**RECOMMENDATION MEETING**

1020 NE Northgate Way  
Seattle, WA 98125

3039050-LU

8.0 ITEMIZED RESPONSE TO EDG

FIGURE 1

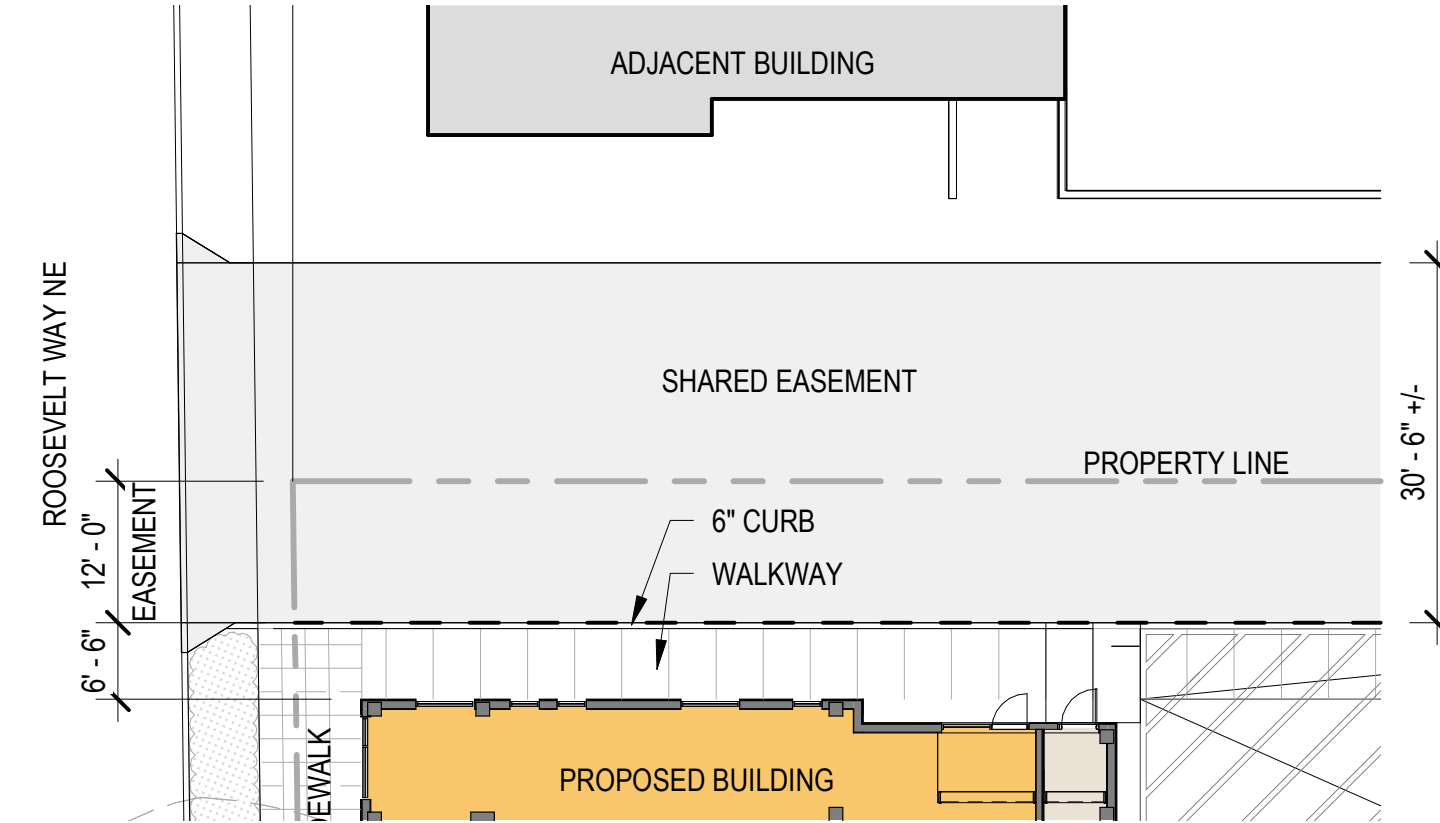
Staff is concerned with the potential for high volumes of automobile traffic concentrated at entry point into the site via a +/-22-foot-wide shared access easement that will need to accommodate, grocery store patrons, residential traffic entering or leaving the site, ride share, delivery, childcare drop off vehicles, and loading dock and solid waste removal vehicular traffic. Staff is also worried about increased conflicts between motorists, and pedestrian and bike traffic as well as possible traffic queuing into Roosevelt Way NE. As such Staff requests alternative design approaches or strategies for reducing air quality, noise, and other impacts to the day care center and playground-as well as other strategies for reducing automobile and pedestrian and bike conflicts. One such strategy ought to include swapping the residential entry and lobby with the childcare center so that it is further away from the easement access point, auto loading and delivery activities and potential poor air quality and noise. This strategy could also include the added benefit of taking advantage of the bioretention pond as an educational feature as well as closer proximity to Victory Creek Park. (CS2-A-1, CS2-C-2, CS2-C-2, CS2-D, CS2-I-I, DC1-II-ii, DC1-IV-i)

Refer to Figure 1. The applicant has reached out to a traffic study consultant to evaluate the volumes of automobile traffic at the shared easement and neighboring streets. Additionally, the drive aisle has since been widened so no part of the adjacent pedestrian walkway resides in the easement, making the aisle at least 24’ wide when combined with the neighboring site. Lastly, discussion about providing a ground-level day care is ongoing so a general sales and services commercial use is currently predicted for the space. The ground-level playground and daycare drop-off zone has since been removed from the plans so there is no vehicular conflict or other detriments.

FIGURE 2

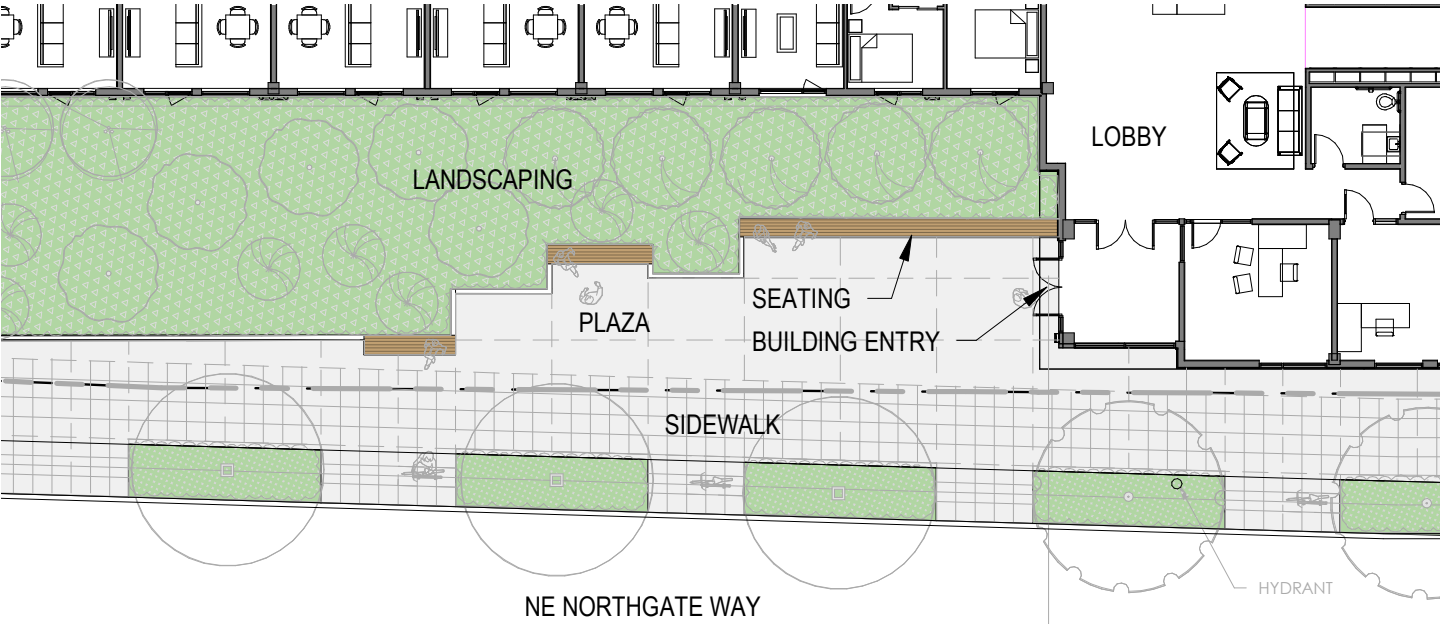
Staff supports the idea of providing the residential lobby and entry along the Northgate Way frontage but questions why there doesn't appear to be greater transparency or a stronger indoor/outdoor connection with the large ground level courtyard. The applicant shall provide details for the residential entry and lobby and their relationship with the large courtyard space. (PL2-A-1, PL2-C-1, PL3-A-2, DC1-IIIi, DC3-A-1)

Staff suggests further exploration of the entry transition being rotated so that it has a greater visual or physical connection to the ground floor courtyard. (DC3-A-1, DC3-C-2)

Refer to Figure 2 and Landscape plans. The residential lobby has been rotated ninety degrees to face the courtyard and to better engage the public space. Informed by staff EDG comments, seating is also proposed in the courtyard to foster a welcoming space away from NE Northgate Way.

Noted. Rotation of entry completed as suggested.

FIGURE 5

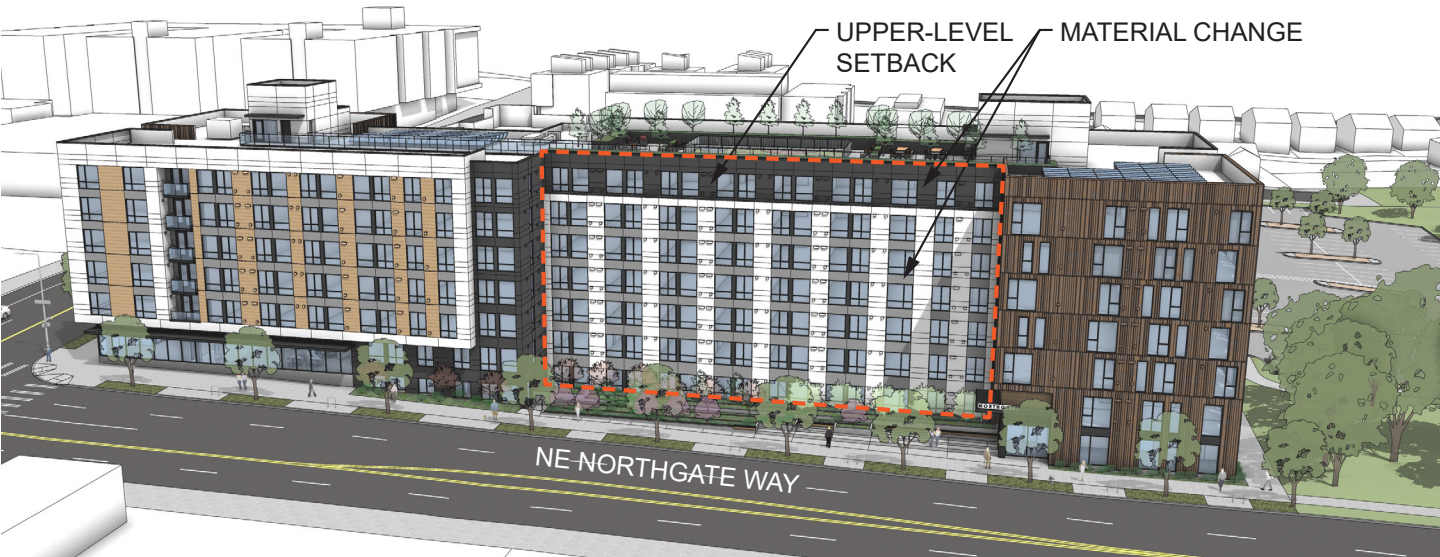
The tripartite façade facing Northgate Way has two lengthy sections with little modulation at the upper levels. The one recessed column of balconies represents a credible beginning. The rest of these two major façade segments should possess a series of either recessed balconies or a clear set of volumetric elements that reduce the façade segments to clear, rhythmic cadences. Secondary elements such as Juliette balconies and over framing would not be adequate to reduce the 268 linear feet that two of the facade segments represent. The lengthy street level façade segments will need to possess incident and interest such as art elements, interesting materials in addition to responding to the conditions (busy pedestrian corner, landscaped court, residential entry/amenity area next to bio-retention pond/park).

See Figures 5 and 6 and Landscape sheets on pages 25-29. Per this suggestion, upper-level setbacks on the south and north facades have been introduced to provide a unique datum that breaks up the building height between the east and west masses. Additionally, material changes help gang up window patterns both horizontally and vertically, making said rhythmic cadences.

FIGURE 7

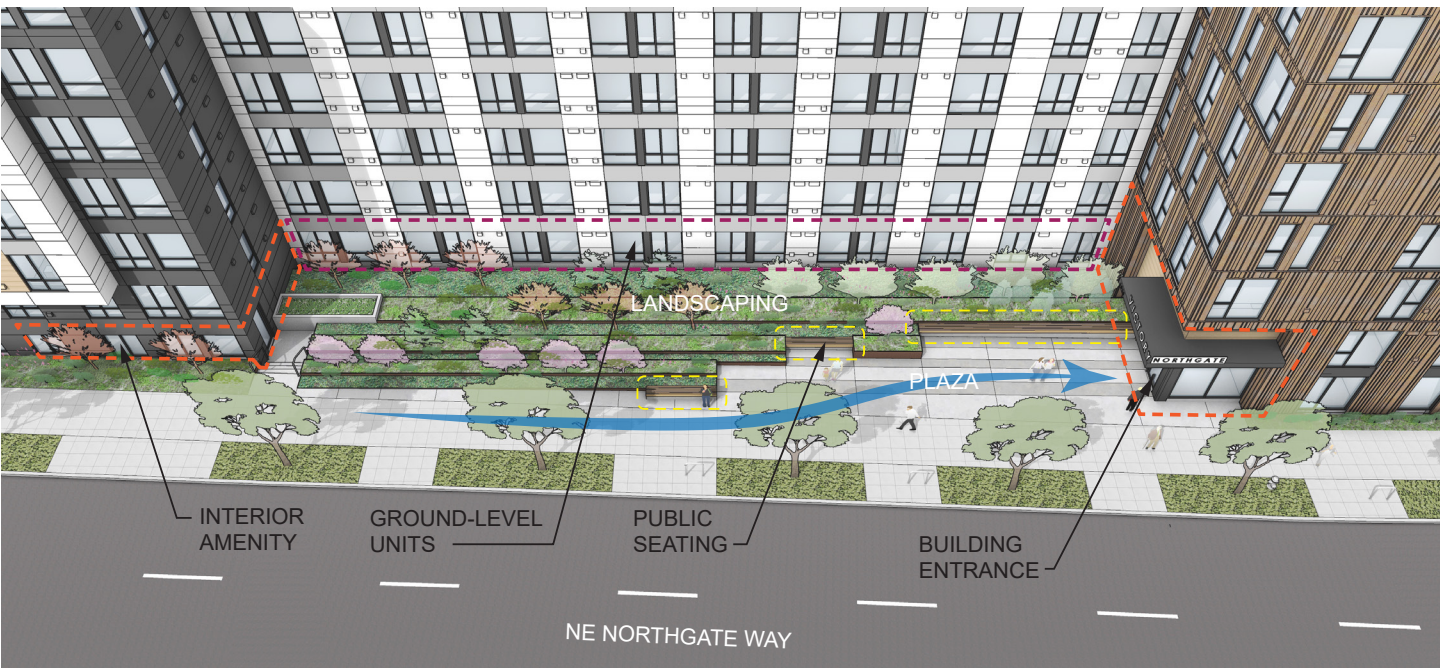
Staff generally supports the concept of the courtyard and fitness center which face NE Northgate Way. Staff would like to see greater development of the courtyard area and how it connects to the various indoor spaces. SDCI advises against developing a series of outdoor warrens for each of the apartment units facing the open space. How is the edge of the court and the right of way manifested? (PL3-C-1, PL1-I-I, DC3-B-3, DC3-C-1)

The ground-level residential units should have a clear relationship to the internal courtyards. The design team shall provide vignettes and other details of the interior courtyard space depicting landscaping, fence design if any, paving material, seating, and lighting where applicable. (PL1-1-b, PL1-2-b, PL1-2-c, PL1-3-a, PL1-I-i, DC3-A-1, DC3-B-1 DC2-I ii.)

See Figure 7. Informed by Administrative EDG, the fitness center has moved to the north facade where it is less visible, and a community recreation area is now proposed along NE Northgate Way. This space is anticipated to be a lounge-like amenity that will fit well for its prominent location along the street and in response, ample glazing is proposed to visually connect the interior and exterior. Informed by Administrative EDG guidance and for the sake of anticipated security concerns, outdoor patios that physically connect the amenity area and the courtyard were not included in the design. An emergency egress door is proposed at the courtyard but will not be an entrance to the building. The same is true for all ground-level units. A buffer zone between the courtyard landscaping and the ground-level units is proposed, but no walk-out patios are proposed due to security concerns. The courtyard is instead meant to be a neighborhood amenity space accessed from the street rather than an extension of the building's amenity spaces.

See Figure 7 and 8. Vignettes and details are shown of landscape screening for the ground-level units which will help mitigate privacy and security concerns. Hardscape and seating are proposed in the courtyard which lead off of NE Northgate Way and draw people into the site while not so close as to cause noise and privacy concerns for adjacent units. Furthermore, bringing people into the site consequently draws security concerns for ground-level units so no patios are proposed in the courtyard.

FIGURE 9

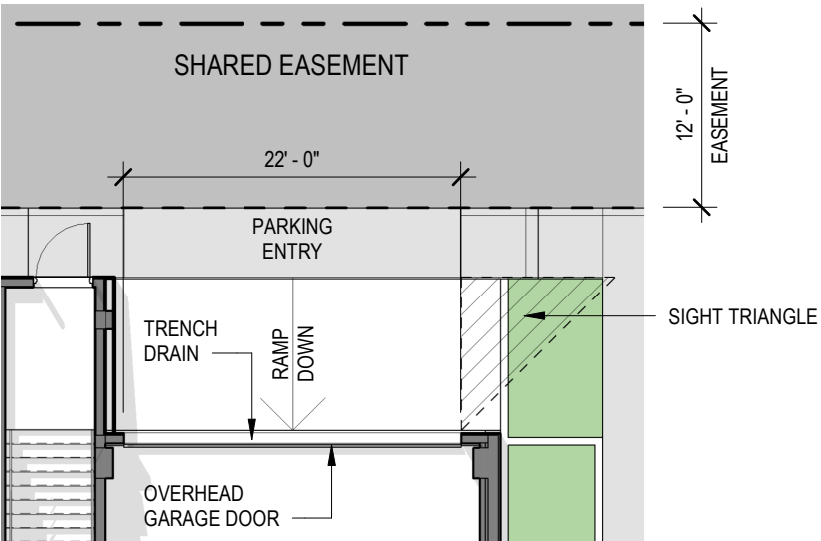
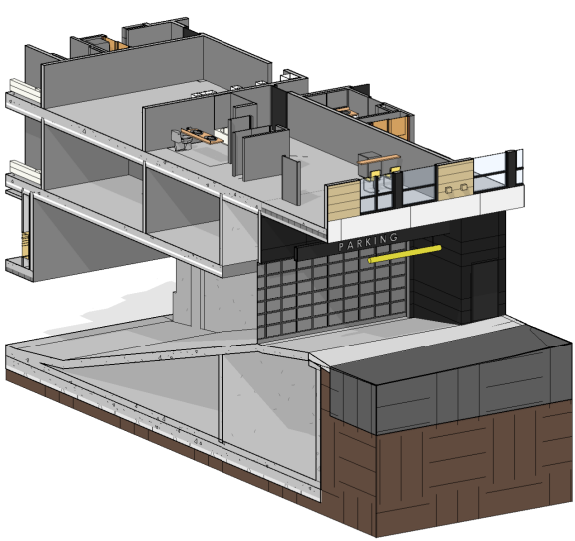
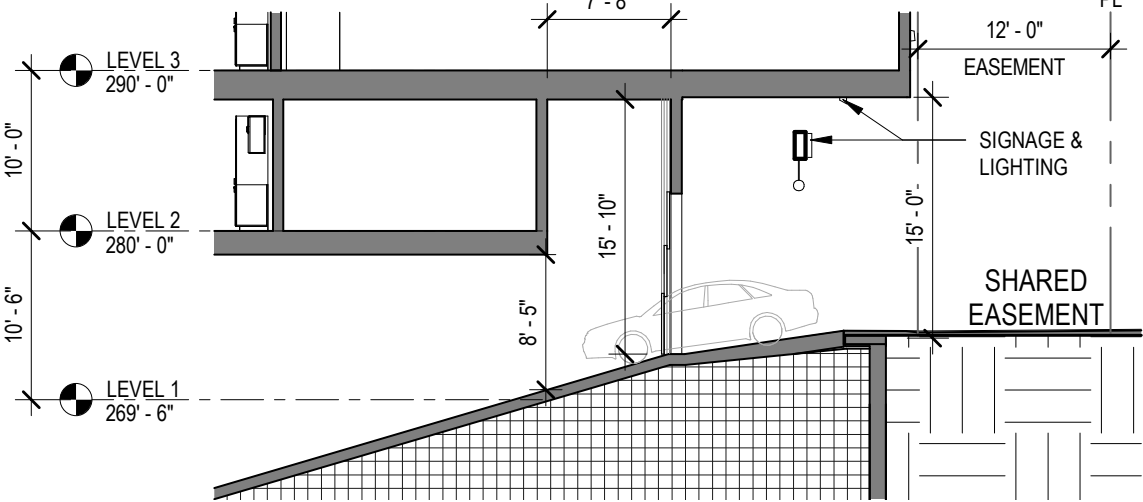
The design team shall provide additional details for how automobiles enter the lower level parking area, including turning radii, alert systems, gate detail, etc. (DC1-B-1)

See Figure 9 and floor plans for additional details as requested. The garage will be accessed from the shared easement via an overhead rolling door. One view triangle is required on the exit side of the two-way parking ramp. No safety mirror is required or provided due to the view triangle and its lack of necessity. Additionally, no minimum turning radii is required for the garage drive aisles due to the speed ramp not having any turns in its decent to the garage. The small parking ramp near the southeast corner of the garage is less than 5% and can be parking upon. Therefore, it's treated as a parking aisle and not a speed ramp nor driveway.

FIGURE 10

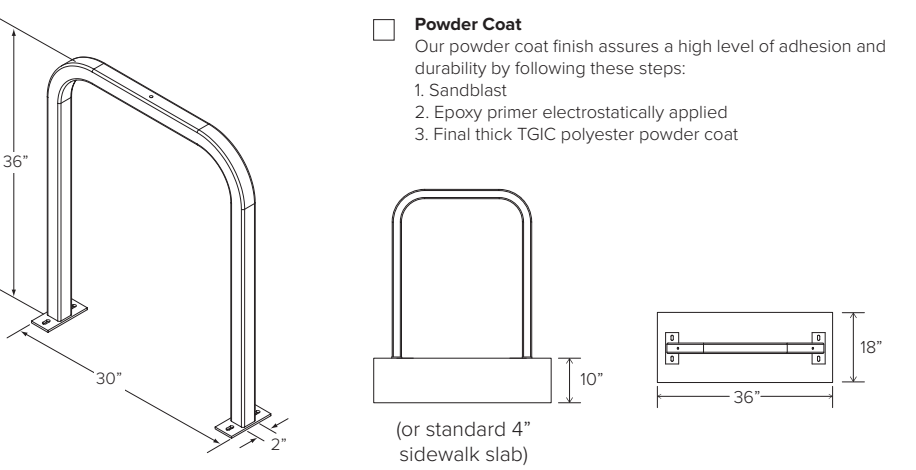
The applicant team shall provide details and the location of short-term bike parking thoughtfully designed for ease of use. In addition, Staff requests more information on the long-term bike storage for the Recommendation phase of review. (PL4-B-1, PL4-B-2, PL4-B-3, PL1-3-h)

See Figures 10, 11, and site plan for said parking details and information as suggested. U-racks with a power-coated finish are proposed around the site for short-term parking, both in the right-of-way and within the property line. Double-decker parking racks will be provided for long-term parking within the building in a secured room. Charging stations can be provided for electric bikes.

FIGURE 12

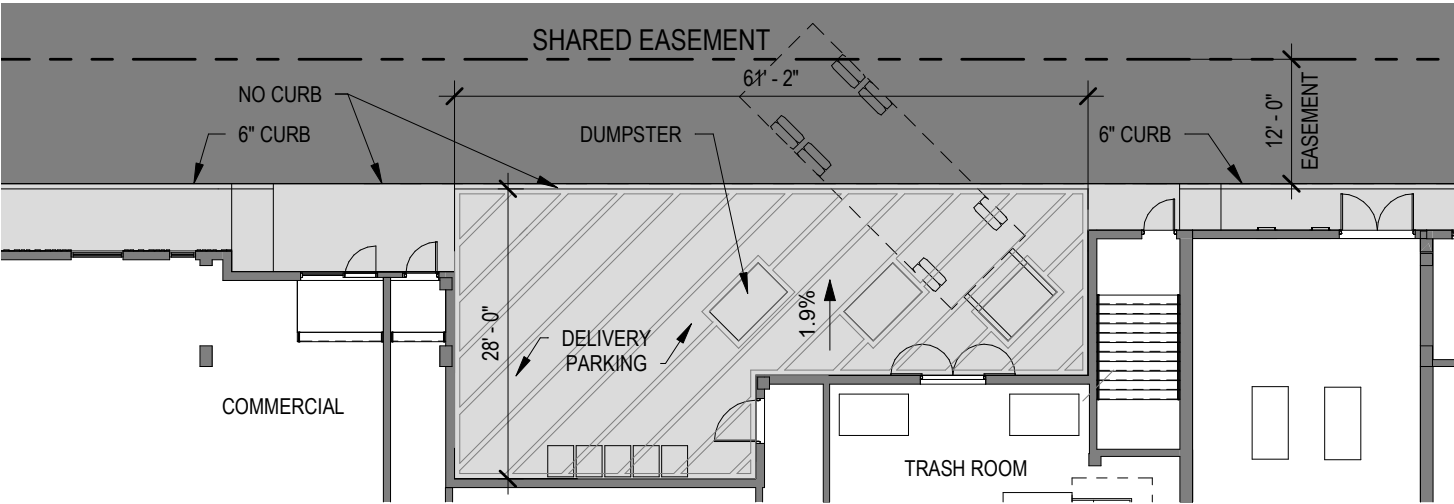
Staff request additional information for all service deliveries and daycare drop off and pick up schemes, including details showing the condition of the street edge and entry transition into the daycare facility. (PL4, PL4-B-1, PL1-3-h.)

See Figure 12. Since Administrative EDG, the daycare, playground, and drop-off zone have been removed from the project. The recessed area facing the shared easement is reserved for trash staging and service deliveries. Coordination between trash collection and deliveries will be made by management to ensure the space isn't occupied by both agencies for certain hours of the day.

FIGURE 13

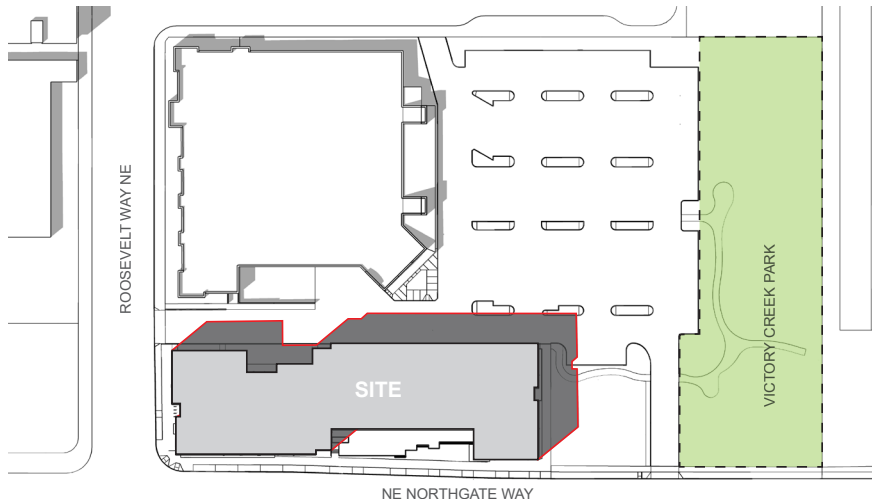
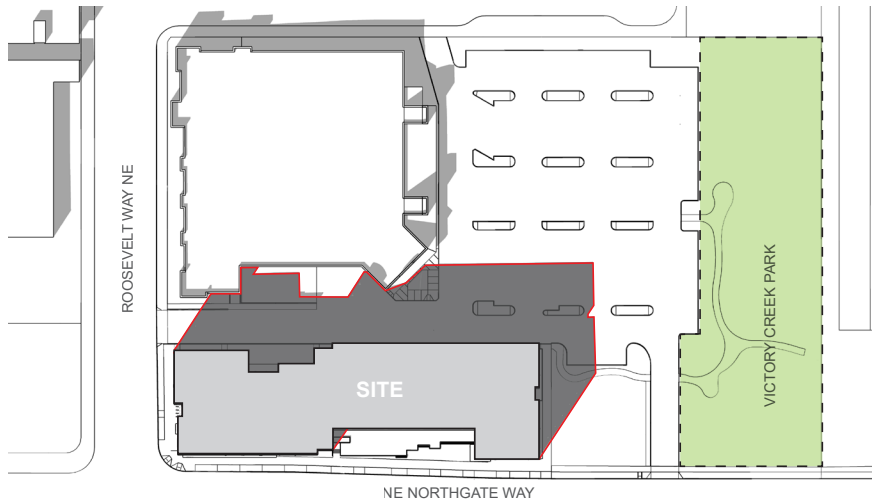
While it doesn't appear to have an impact, the applicant team shall show the relationship of the building height and potential shadows cast on the nearby Victory Creek Park. DC2-A-2, DC2-C-3

See Figure 13 for relationship of building height and potential shadows. The building's shadow with respect to victory creek park has been studied and determined to have no large impact on the site with Winter being the only time of year where a portion of the park will be cast in shadow before 3PM.

BUILDING SECTION AT PARKING RAMP

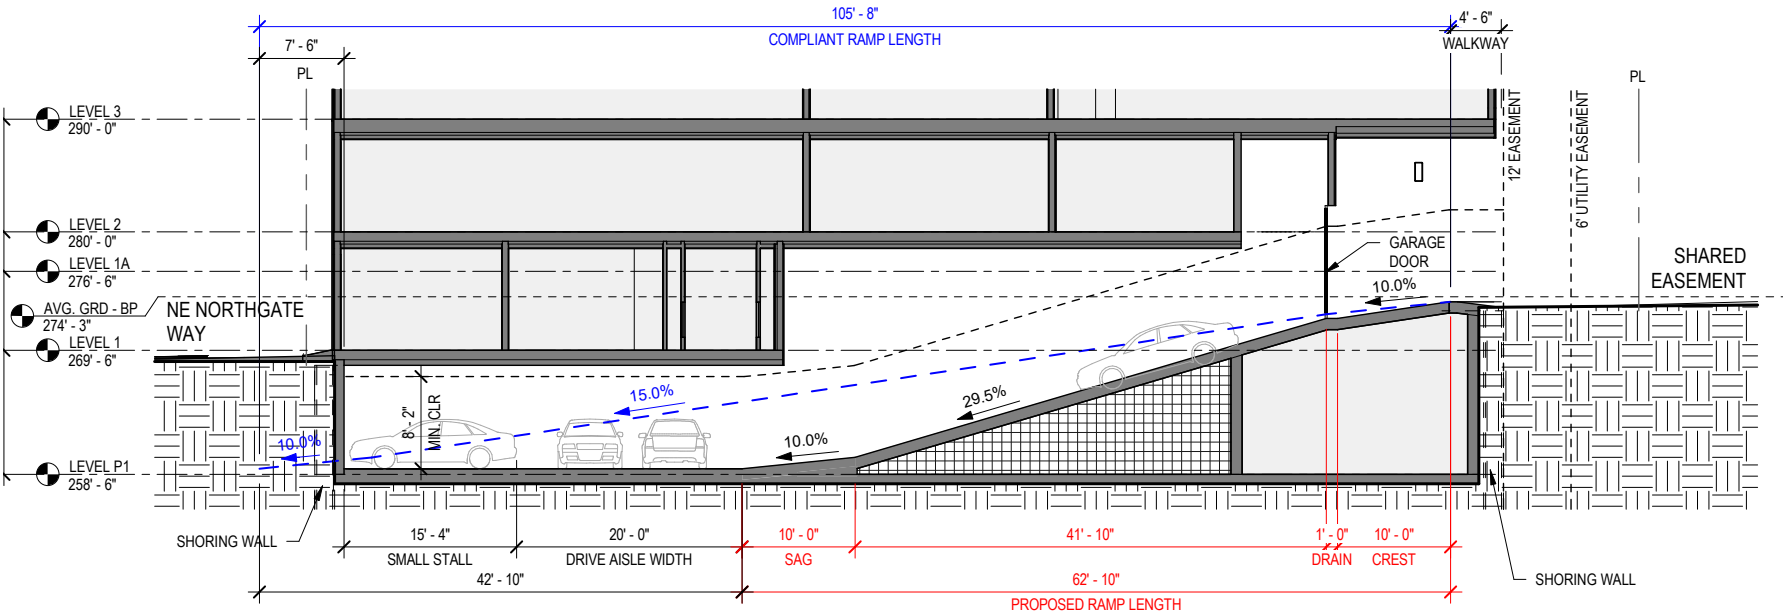
**DRIVEWAY SLOPE SMC 23.54.030.D.3** - The applicant is requesting to be allowed to use a parking ramp with a maximum slope of 23.2% which exceeds the code maximum of 15.0%.

See page 48 for information pertaining to the requested adjustment. A driveway slope exceeding 15% per SMC 23.54.030.D.3 Is still requested and is detailed on sheet A0.11. A parking ratio exceeding the limits described per SMC 23.54.030.B.1.B. is no longer requested and has been removed.
